Access Compliance Report

Public Rights-of-Way

Intersection ID: 15195	Main Street: ALBEMARLE_RD	Cross Street: FARM_POND_LN	Location: SE
ADA ID: 0335BC3BE9A3	Ramp Type: Perp	Initial Pass/Fail: Fail	Overall Compliance: No
Severity Score: 21.25			
Codes/Mitigation Info/Possible Solution		Field Measurements/Component Compliance

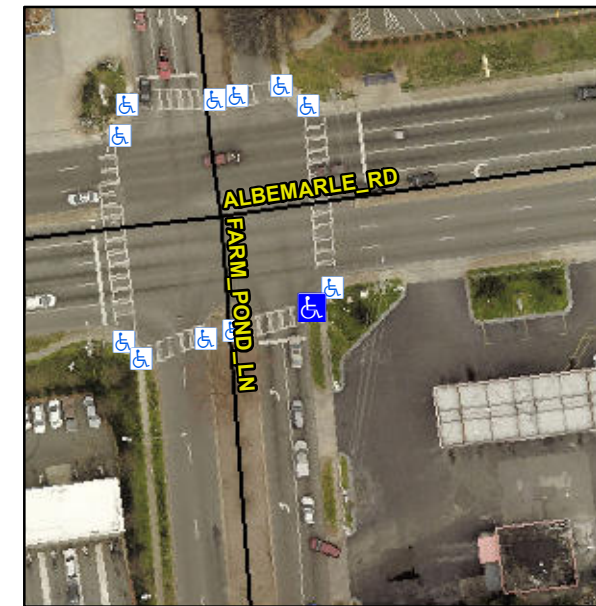
Not Found, R304.5.1, R304.5.3

Compliance	Description	Data	Compliance	Description	Data
N/A	Ramp Length (in)	65.0	Yes	Ramp Slope (%)	7.3
No	Ramp Width (in)	45.0	No	Ramp XSlope (%)	5.4
N/A	Flare Type LT	N/A	N/A	Flare Type RT	N/A
N/A	Flare Slope LT (%)	N/A	N/A	Flare Slope RT (%)	N/A
N/A	Flare Traversable LT?	N/A	N/A	Flare Traversable RT?	N/A
N/A	Landing Length (in)	N/A	N/A	DWS Provided?	N/A
N/A	Landing Width (in)	N/A	N/A	DWS Contrast?	N/A
N/A	Landing Slope (%)	N/A	N/A	DWS Length (in)	N/A
N/A	Landing X Slope (%)	N/A	N/A	DWS Full Width?	N/A
N/A	Landing Curb? (Y/N)	N/A	N/A	DWS Offset (in)	N/A
N/A	Shared Landing?	N/A			
N/A	Gutter Ponding?	N/A	N/A	Gutter Slope (%)	N/A
N/A	Gutter Lip Ht (in)	N/A	N/A	Gutter X Slope (%)	N/A
N/A	Painted X Walk1?	Yes	N/A	Painted X Walk2?	N/A
	X Walk 1 Direction	To W		X Walk 2 Direction	N/A
N/A	X Walk 1 Width (in)	110.0	N/A	X Walk 2 Width (in)	N/A
	X Walk 1 Slope (%)	2.3		X Walk 2 Slope (%)	N/A
	X Walk 1 X Slope (%)	5.8		X Walk 2 X Slope (%)	N/A

Remove & Replace Entire Ramp.
